City Creek Water Treatment Plant - BRIC

Haskell Project No. 6704187
90% GMP Bid Package

Addendum #4

RFI Log

SALT LAKE CITY DEPARTMENT OF PUBLIC UTILITIES													
CITY CREEK TREATMENT PLANT UPGRADES													
BRIC PACKAGE													
DUCTBANK SECTIONS 1

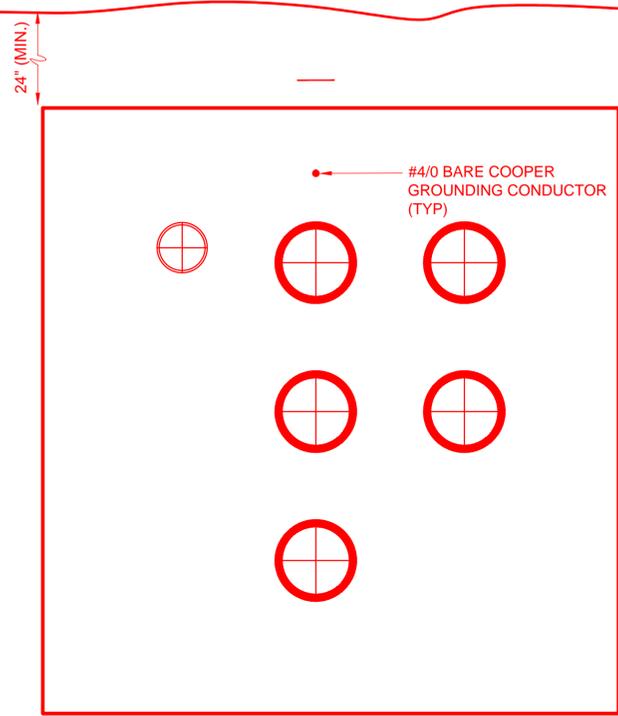
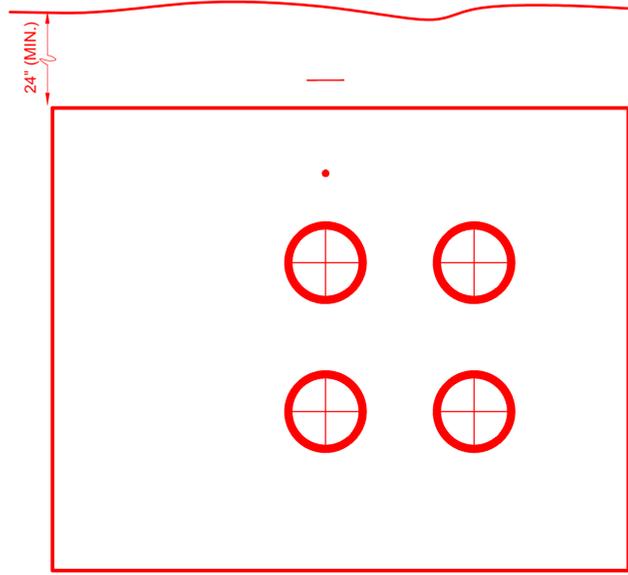
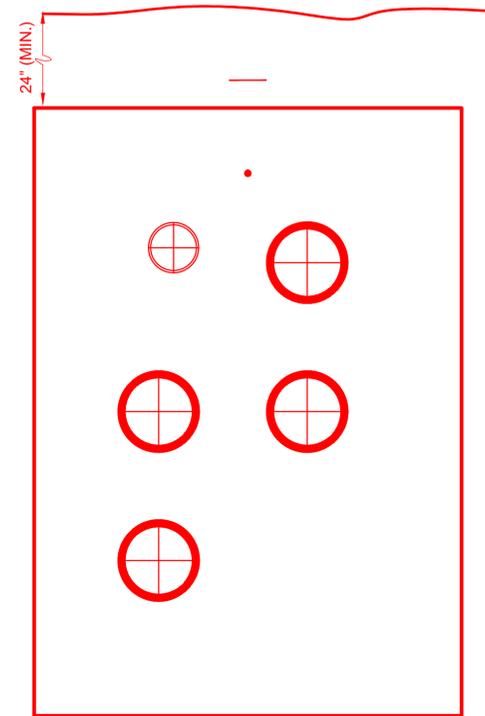
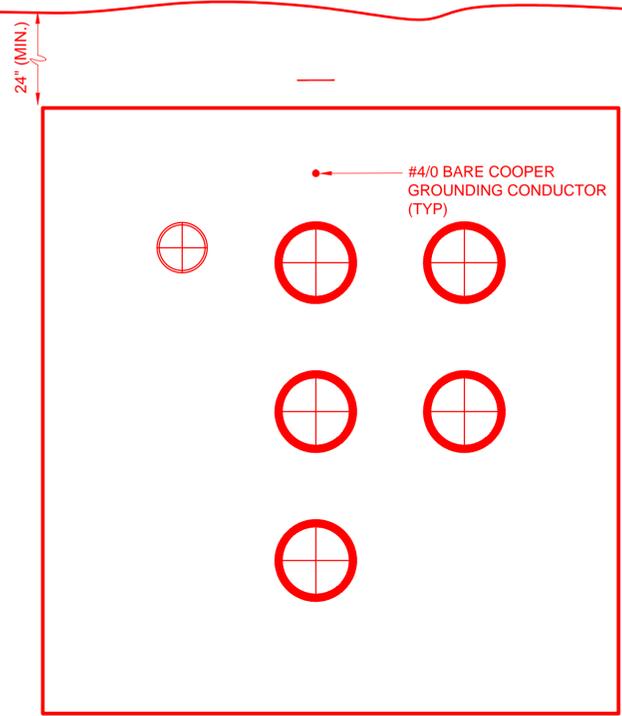
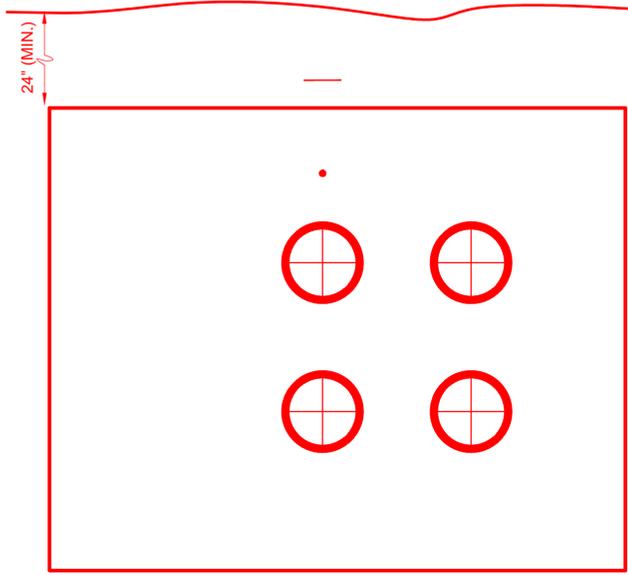
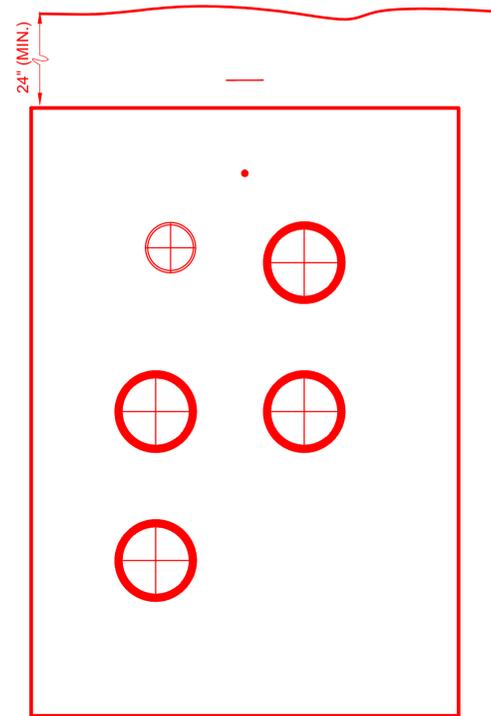
142	ER	Sections 5, 6, & 7 referenced on 01-E-03 appear to be missing from 01-E-07, there is no section 1 shown on 01-E-03 as referenced for DB-05 (01-E-07), and DB-03 (01-E-06) references two different sections on 01-E-03 indicating these conduits and cables are located in two different places. Please clarify duct bank information	01-E-03	26	7/15/24	7/31/24	8/2/24	4	David Star	See RFI 142 attachments
143	ER	01 12 16, 1.10A 2 mentions a temporary standby generator being in place during the demo and installation of the permanent standby generator. Will this temporary standby generator be provided by Haskell, or will the electrical subcontractor need to provide it?		26	7/15/24					
144	ER	6.3.2 10 of the Electrical Scope of Work document states that bidders will identify and select manufacturers and/or suppliers that implement materials with recycled content, along with some other requirements. We are looking into this, but there may be a chance our electrical gear manufacturers do not meet these requirements. Can exceptions be made?		26	7/15/24

DRAWING NO.
01-E-02

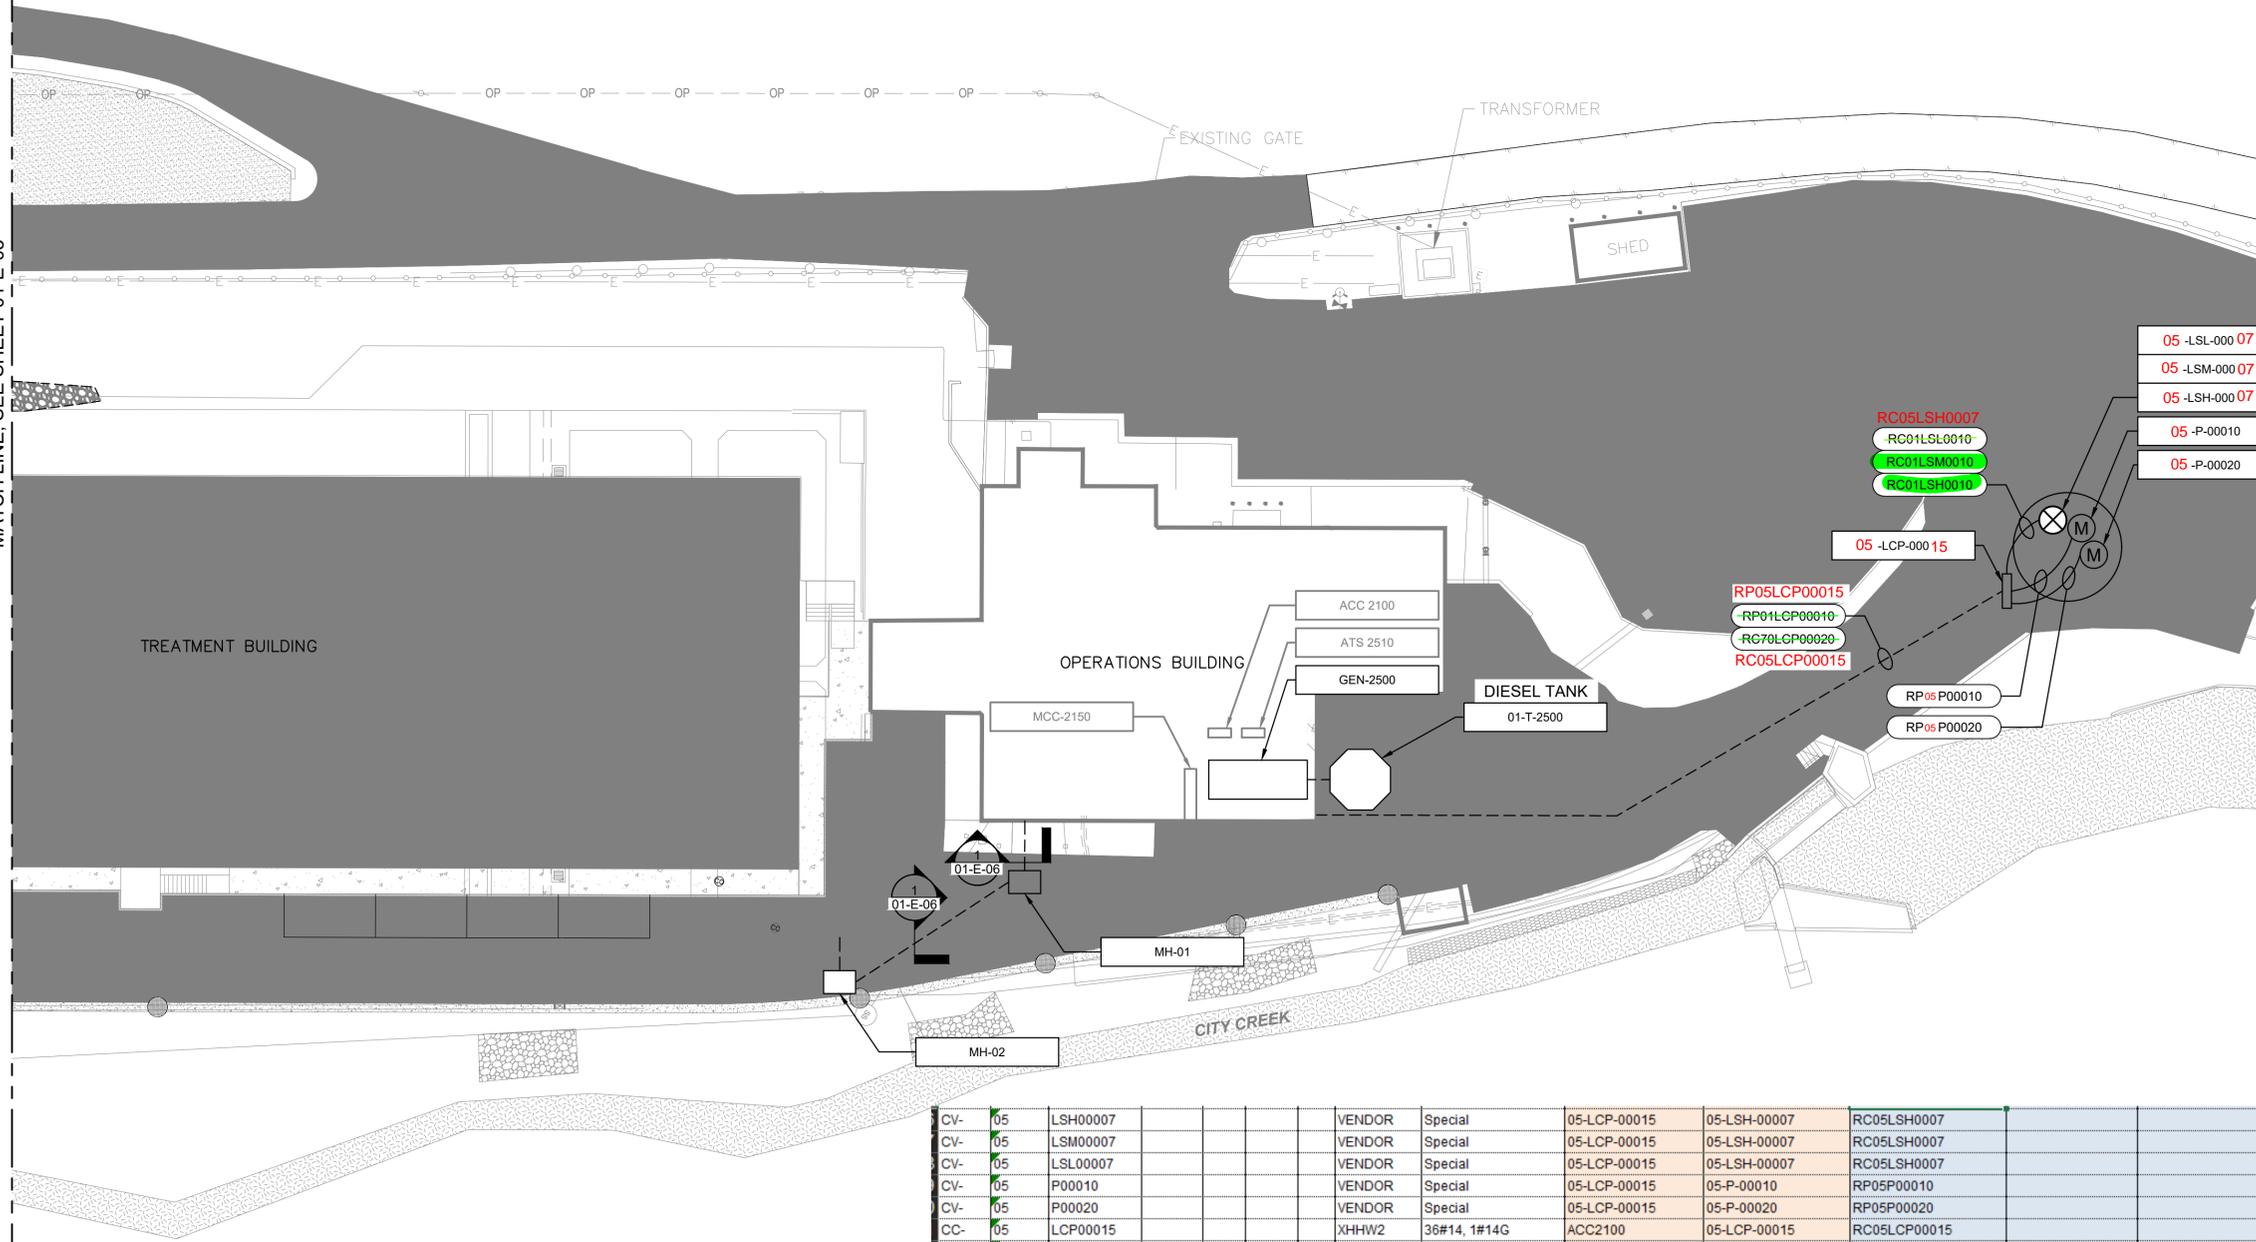
145	ER	Drawing 01-E-02 shows a tank/vault to the east of the operations building in/on the roadway. None of the items shown (01-LCP-00010, RP01LCP00010, 01-P-00010, etc.) appear to be shown in the one-lines, panel schedules, cable schedules, raceway schedules, or P&IDs. Please provide information for these items.	01-E-02	26	7/15/24	7/31/24	8/2/24	4	David Star	See RFI 145 attachments
146	ER	Please provide dimensions for stand-by generator for installation pricing purposes.		26	7/15/24	7/30/24	8/2/24	4	David Star	The generator has been laid out based on a Cat C32 1000kw (1250kVA) generator set. Dimensions L 182.6 x W 66.3 x H 85.1
147	ER	Drawing 01-E-03 indicates where the utility XFMR will be located. Is there an existing pad/vault located there, or will this be a new service drop needing a new pad/vault?	01-E-03	26	7/15/24	7/31/24	8/2/24	4	David Star	The treatment building is getting a new service drop and XFMR and pad.

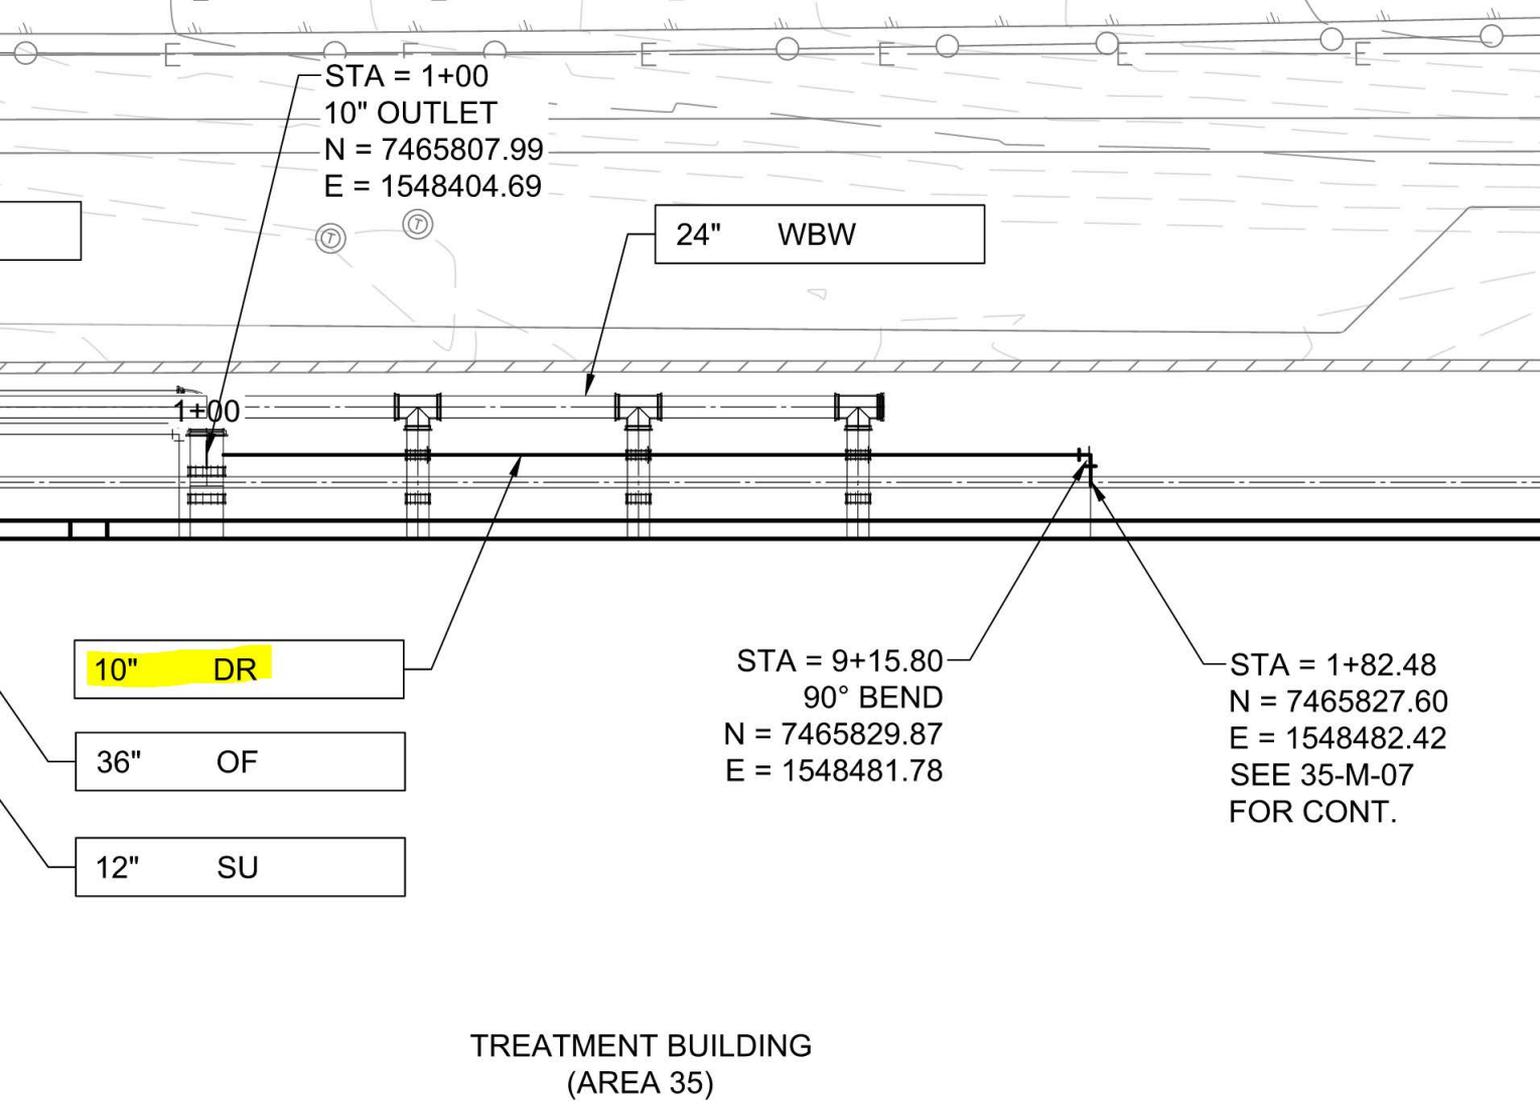
262	KJM	RFI #34 asks a question about whether a Drain line is 12" or 10". The answer doesn't reference that system. We have assumed it to be 10" to match two out of the three Civil Drawings, as well as the Mechanical drawings, best shown on DWG. 35-M-07.	01-C-21, 01-C-22, 01-C-75, 35-M-07	40	7/24/2024	7/30/2024	8/2/24	4	Nic Oltean	North side drain line is 10" DR see figure attached. This will be updated with IFC set.
263	MCL	Detail C/35-A-11 States to see STRUCTURAL drawings regarding the framing for the canopies over the doors at the Treatment Plant. The Structural drawings don't show the canopies at all. Please advise as to the structural framing/connection to building required for the canopies above doors shown on the roof plan on 35-A-01 and in elevations.	C/35-A-11 35-A-01	10	7/25/2024	7/25/2024	7/30/24	3	Greg Short	Detail D/GS-23 Contractor may use Section 40 05 65.23 in lieu of Section 40 05 65.16 for all check valve instances that are not specific to a pump for the following Schedules:
